Atlantic Crossing

CLASS II MODIFICATION 2019 - 8.2.2019

CLASS II MODIFICATION SUPPLEMENT 10.25.2019

PLAZA SUPPLEMENTAL EXHIBITS

BLDG III ELEVATIONS

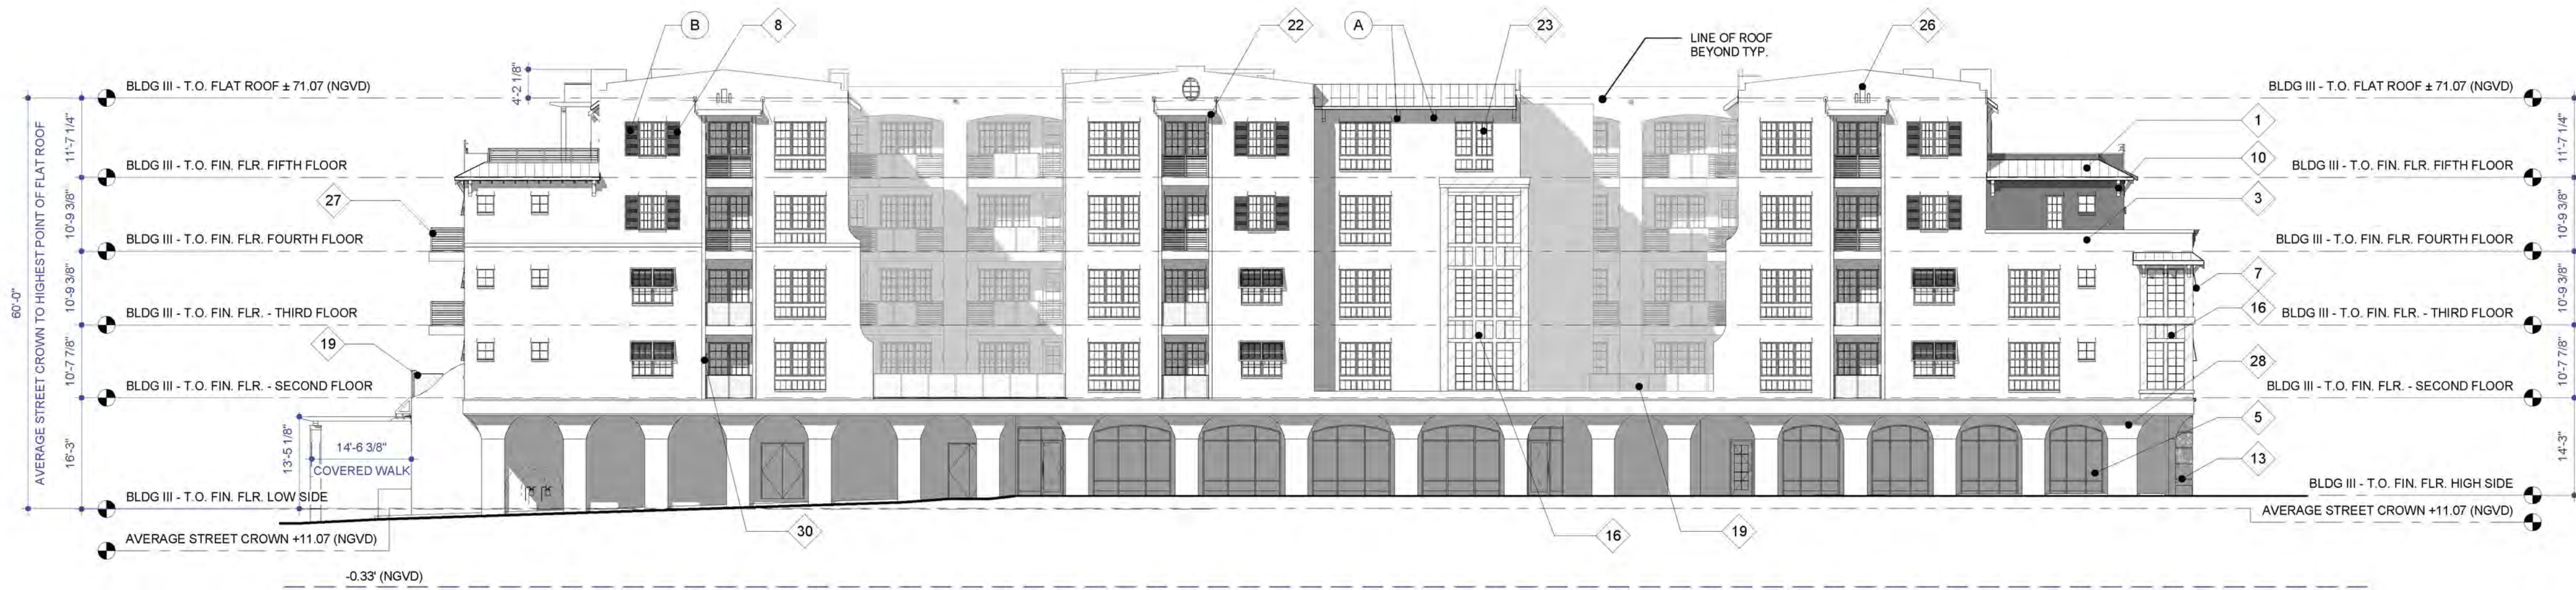
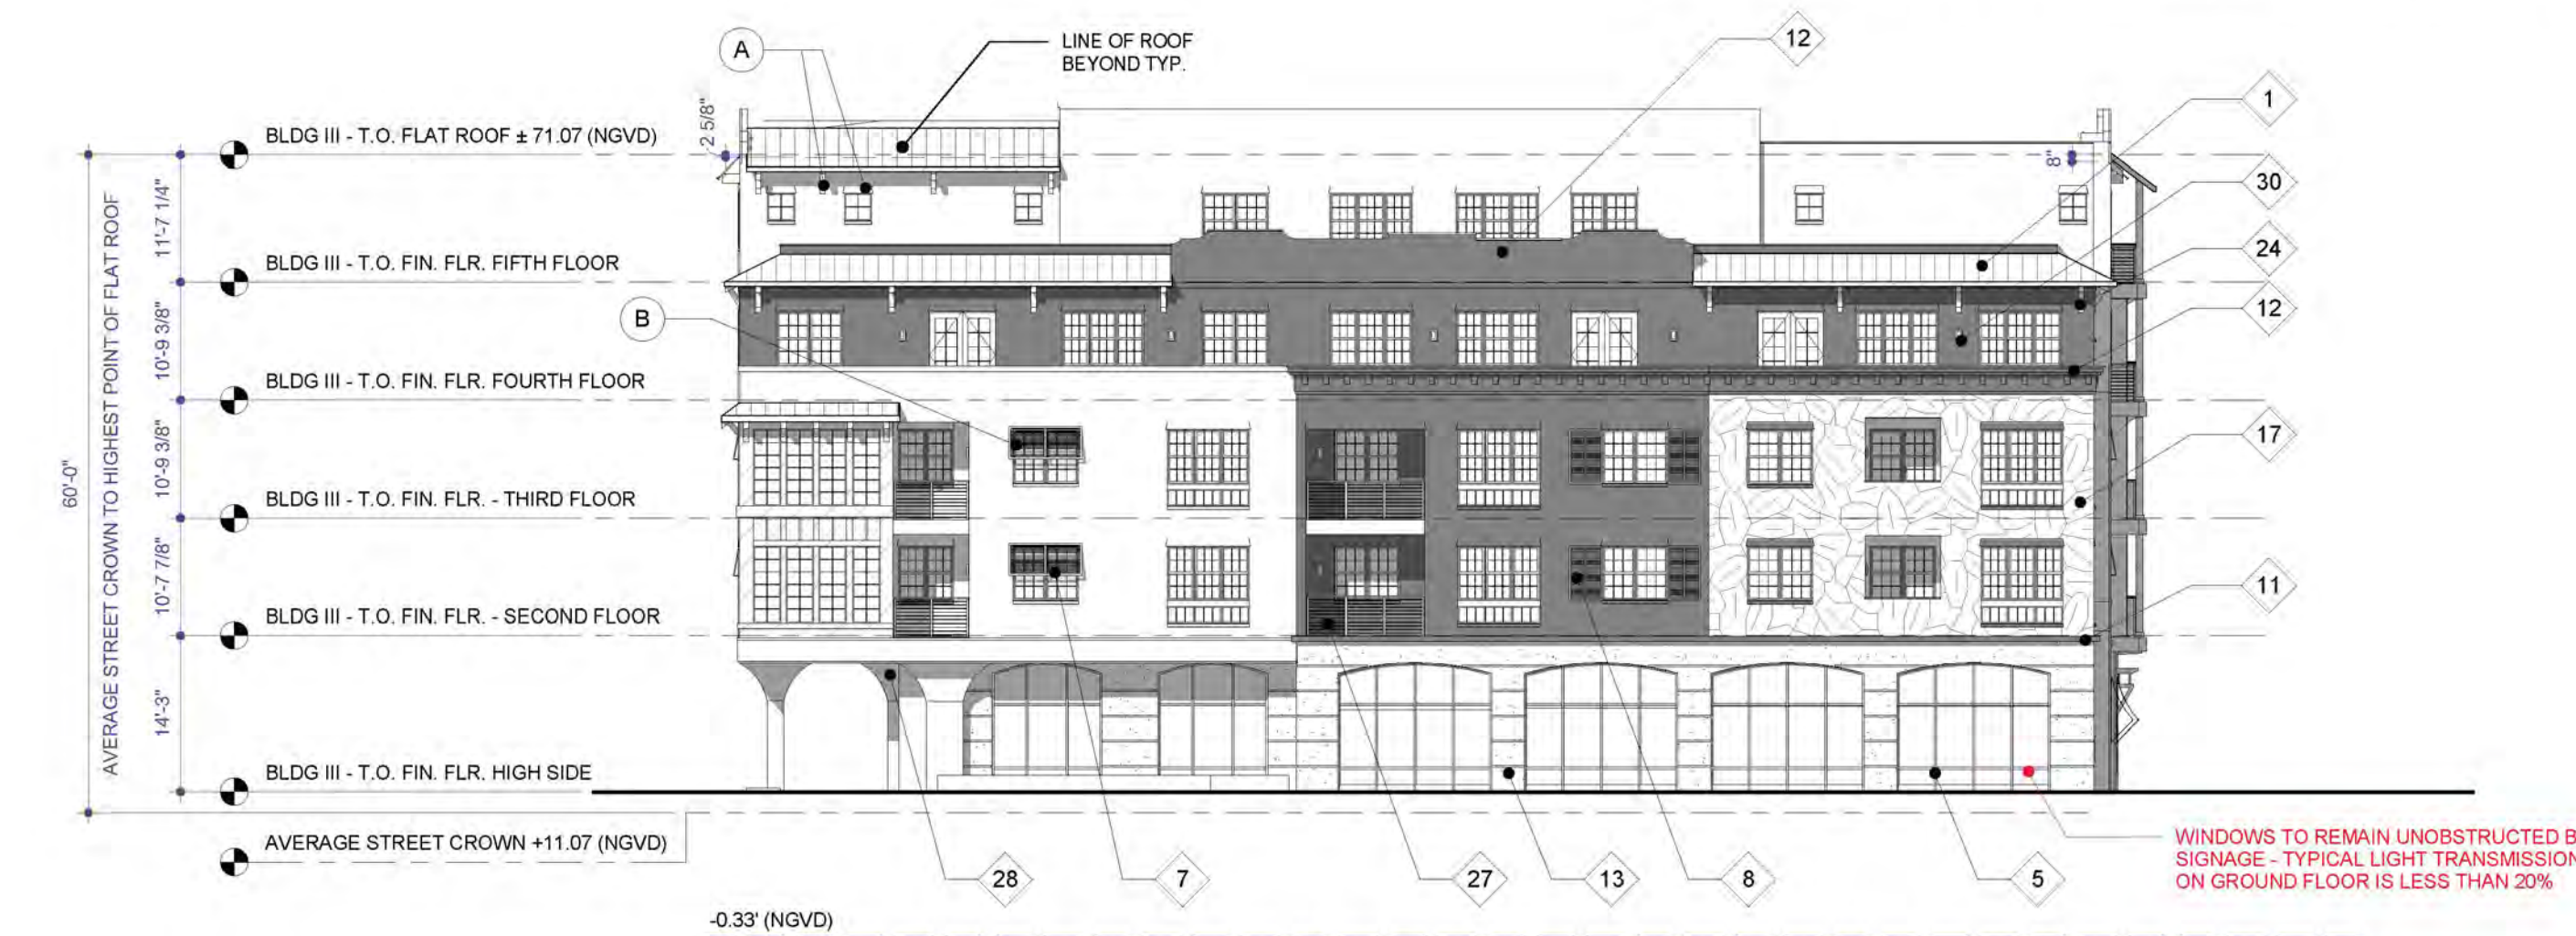
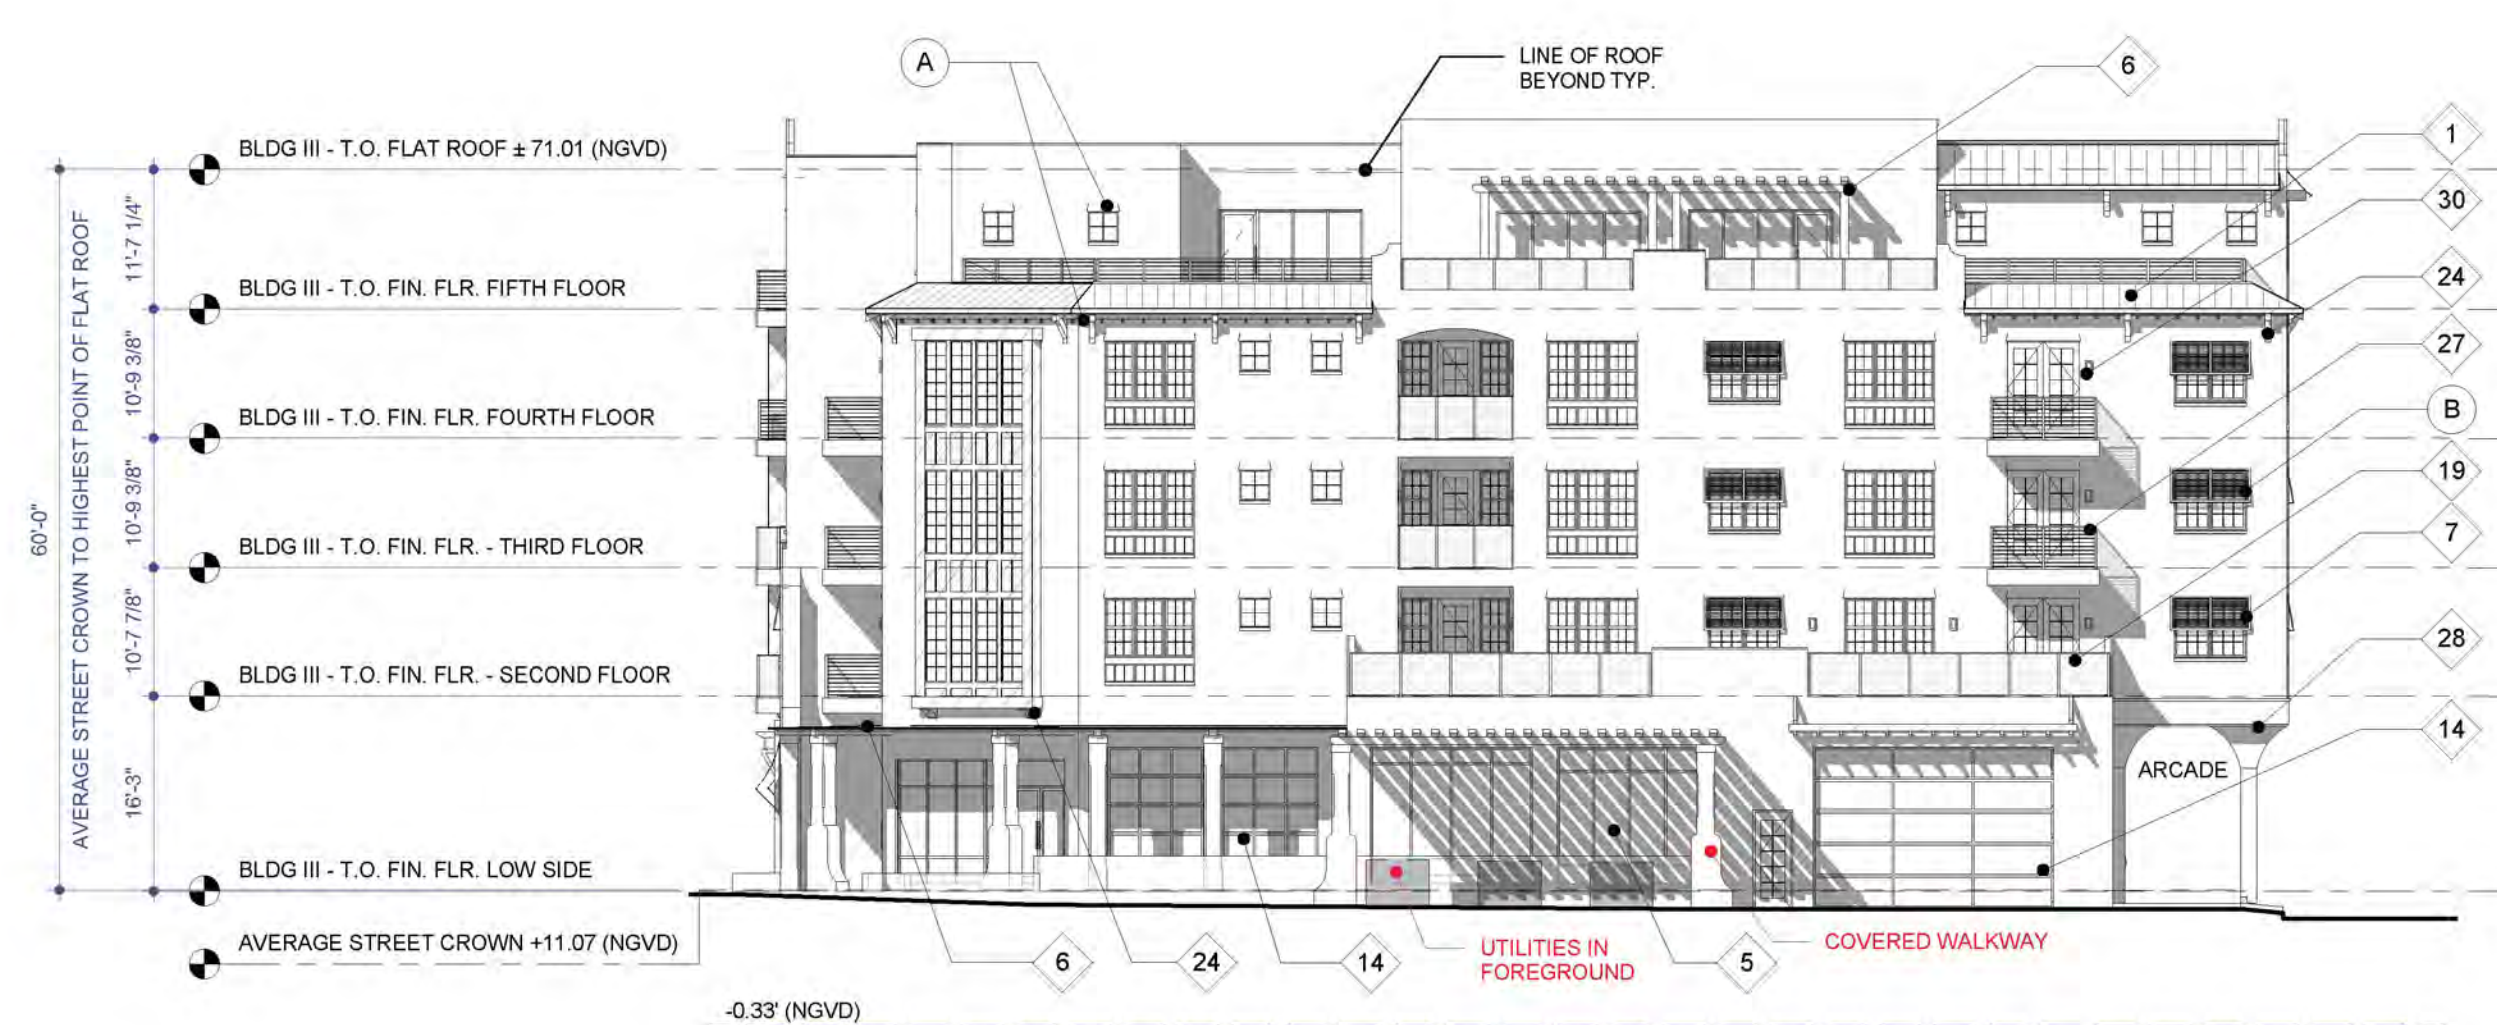
RESPONSE TO 2.12.14 STAFF COMMENTS
• BUILDING III NORTHWEST FOOTPRINT ADJUSTED DUE TO ADDITION OF RAMP AT NE 6TH AVENUE
• WINDOWS OF THE BUSINESSES AND OFFICES REMAIN UNOBSTRUCTED BY SIGNAGE
• LIGHT TRANSMISSION FOR GROUND FLOOR GLASS AREA TO BE NO GREATER THAN 20%
• KNOX BOXES TO BE PROVIDED AT ROLL DOWN GATES
• GREEN WALL IS CONSIDERED A TRELLIS WHICH SHALL BE ALLOWED TO ENCRATCH INTO SETBACK ALONG FEDERAL HIGHWAY
• ADDED INGRESS/EGRESS RAMP AT NE 6TH AVE

SETTLEMENT MODIFICATION 4.21.2017
• ADD ARCADE ALONG THE NORTH ELEVATION
• ADJUST POSITION OF LOADING AREA
• ADJUST EAST AND WEST ELEVATIONS DUE TO ADDITION OF ARCADE.

ARCHITECTURAL ELEVATION REVISIONS 7.19.2018
GENERALLY REVISE ELEVATIONS TO BE MORE CONSISTENT WITH ANGLO CARIBBEAN, INCLUDING:
• SCULPTED FORMS AT ARCADE AND AT FEATURE ELEMENTS OF THE BUILDING
• RE-SCALE WINDOWS AT CORNERS
• WOOD DETAILING AS ACCENT AT VERTICAL FORMS
• ENTRANCE DETAIL AT BUILDING CAP
• RE-DETAIL ARCADE AND LOW ROOF FORMS

BLDG VI ELEVATIONS

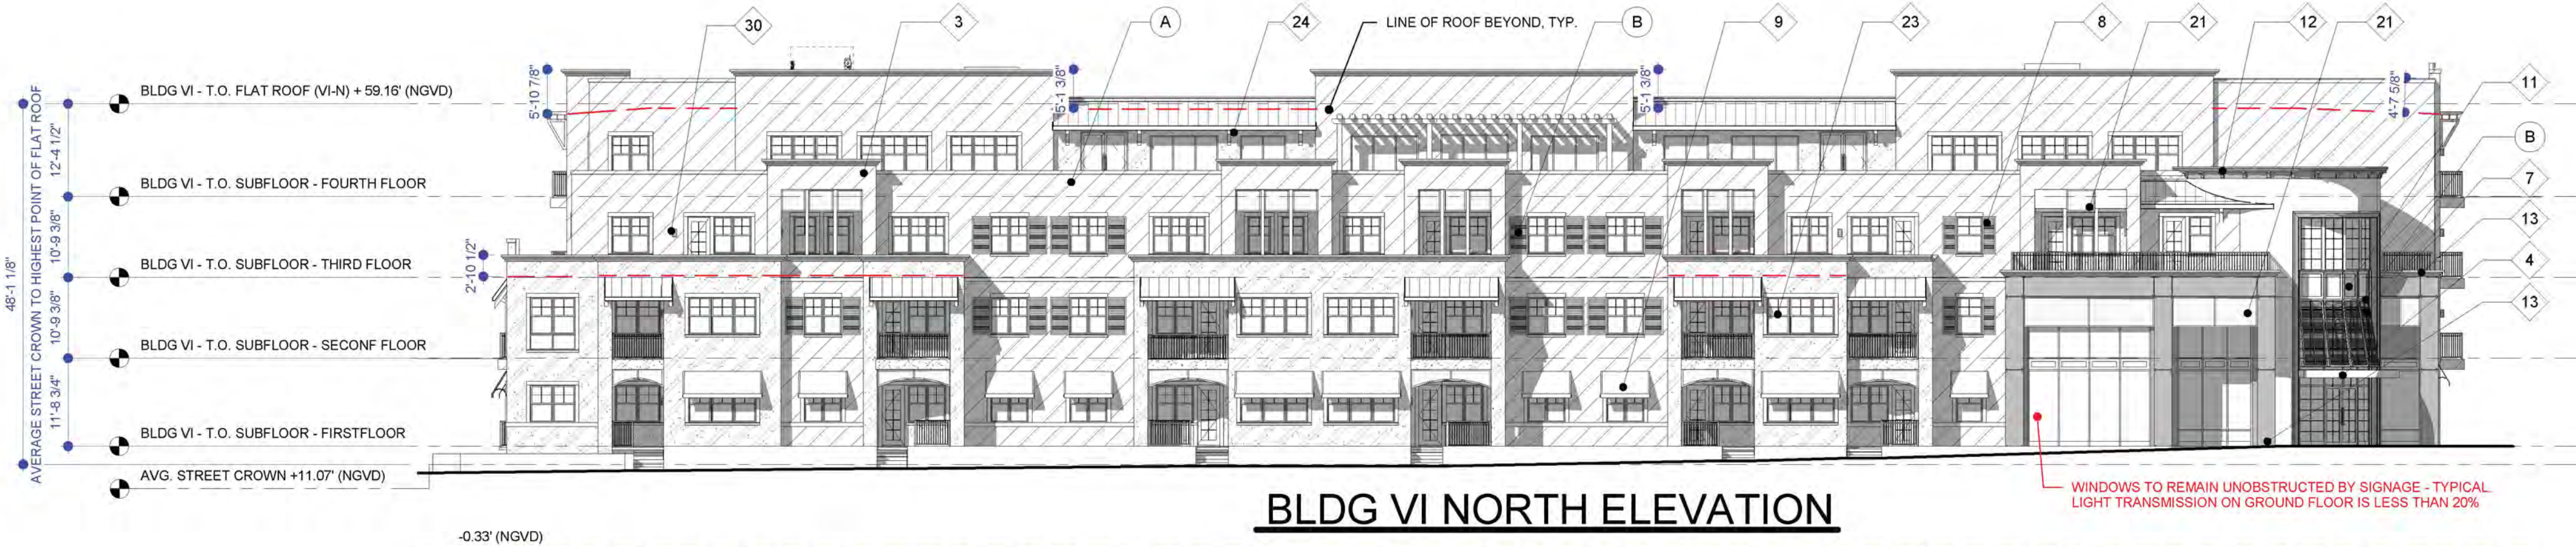
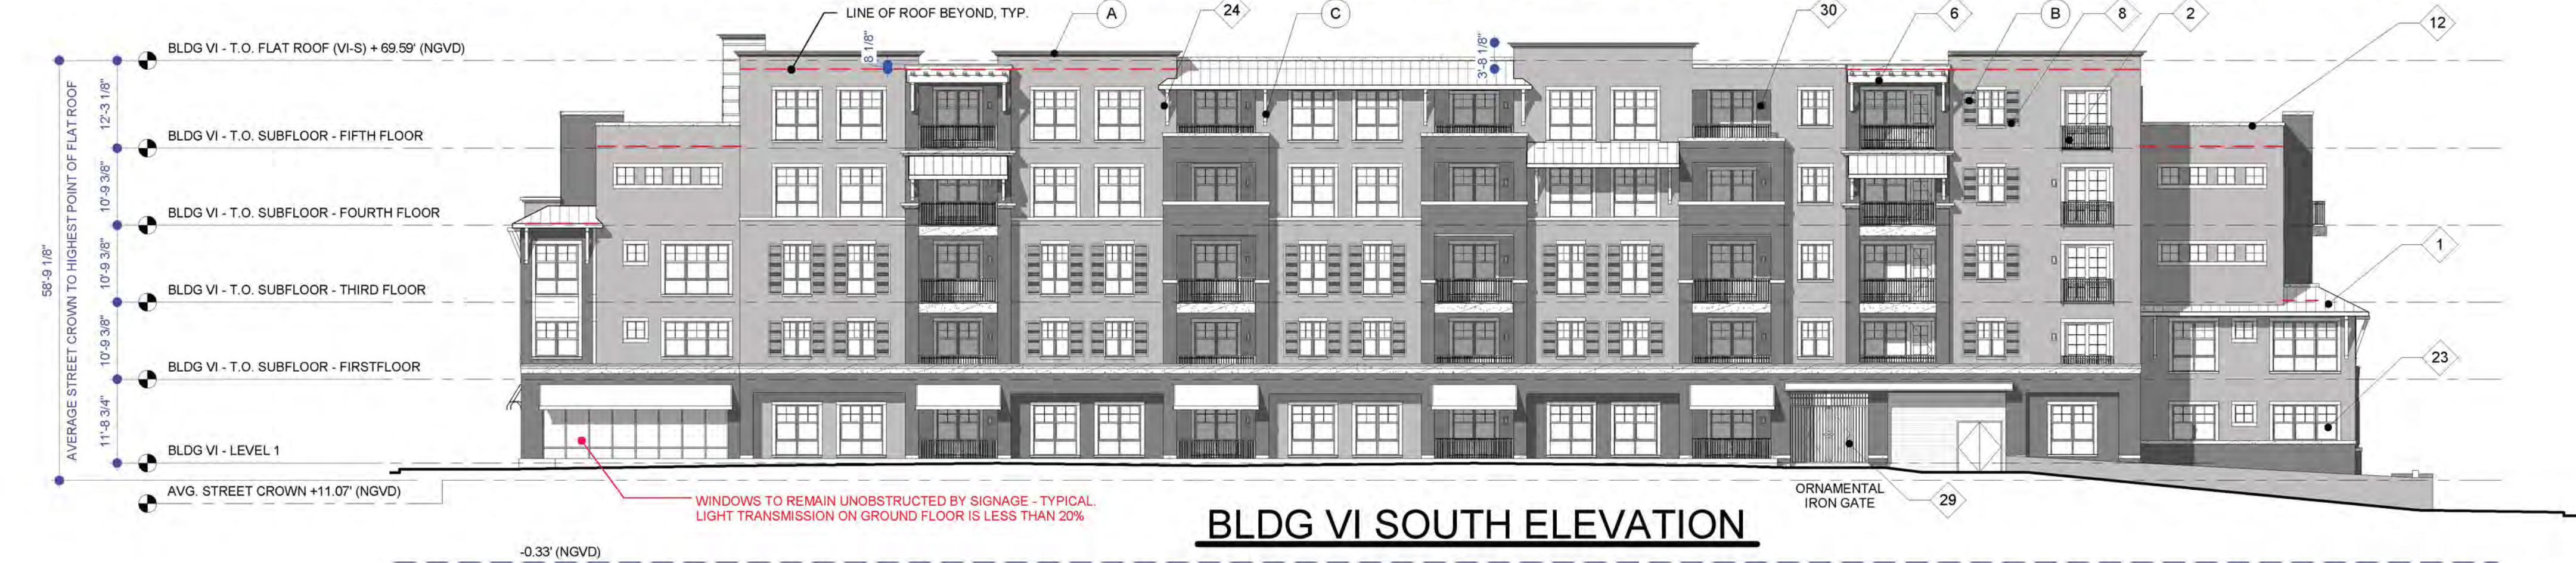
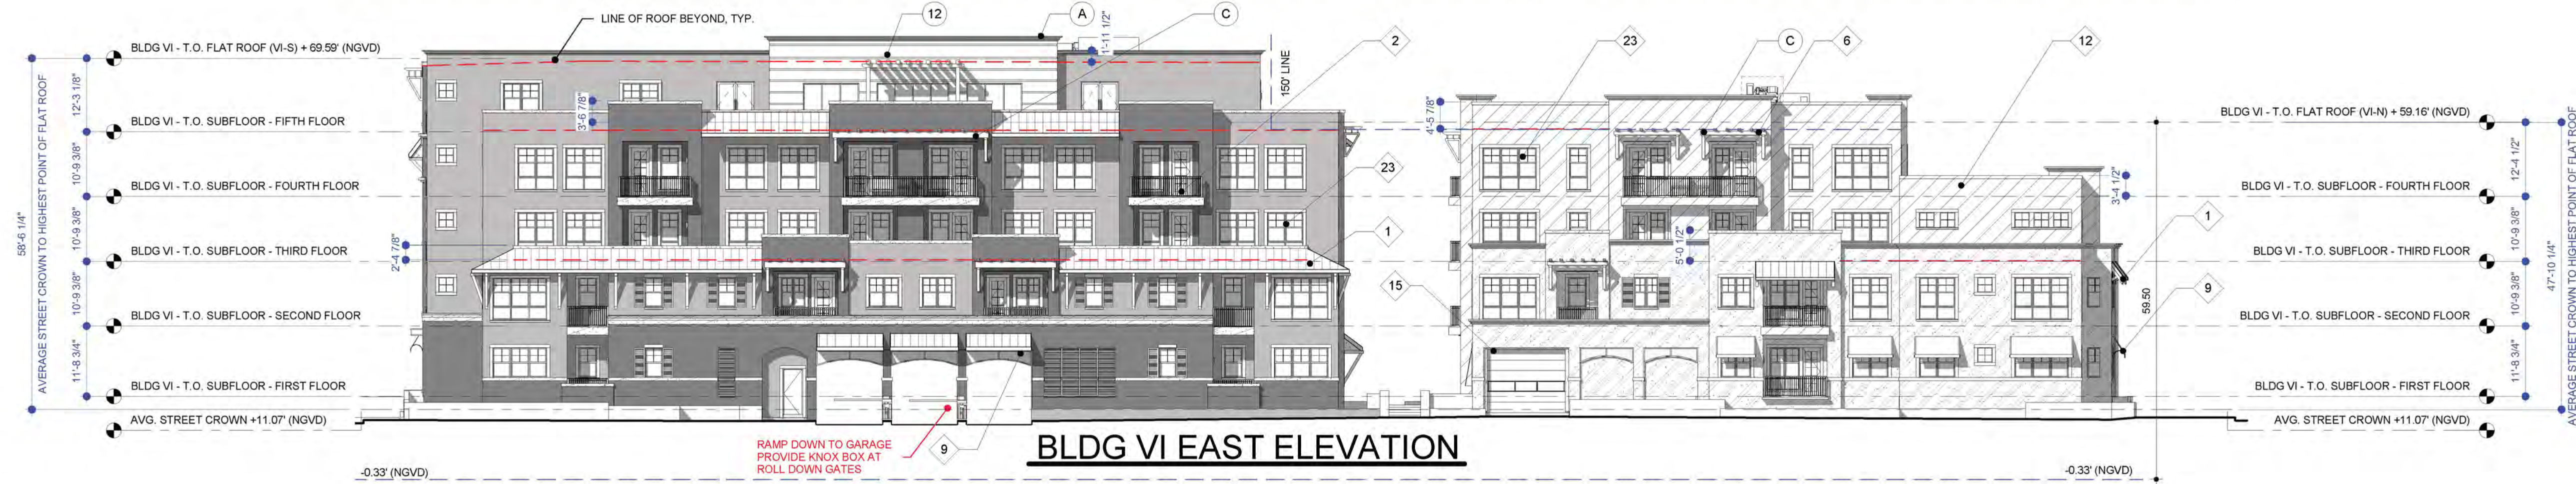
RESPONSE TO 2.12.14 STAFF COMMENTS
• WINDOWS OF THE BUSINESSES AND OFFICES REMAIN UNOBSTRUCTED BY SIGNAGE
• LIGHT TRANSMISSION FOR GROUND FLOOR GLASS AREA TO BE NO GREATER THAN 20%
• KNOX BOXES TO BE PROVIDED AT ROLL DOWN GATES
• ADJUSTED METAL AWNINGS AND ADDED MORE SHUTTERS

SETTLEMENT MODIFICATION 4.21.2017
• RELOCATED ENTRY TO PARKING GARAGE
• ADJUST EAST AND SOUTH DUE TO PARKING GARAGE ENTRY RELOCATION

ARCHITECTURAL ELEVATION REVISIONS 7.19.2018
GENERALLY REVISE ELEVATIONS TO BE MORE CONSISTENT WITH MASONRY MODERN, INCLUDING:

- STRENGTHENING PEDESTRIAN SCALE OF ENTRY TO LEASING (NORTH-WEST CORNER)
- ENHANCED HORIZONTAL DETAILING AT BASE - ADDED ROOF FORMS, CONSOLIDATED COLOR, MINIMIZED TALL SLENDER VERTICAL FORMS
- ENHANCE DETAILING AT BUILDING CORNERS
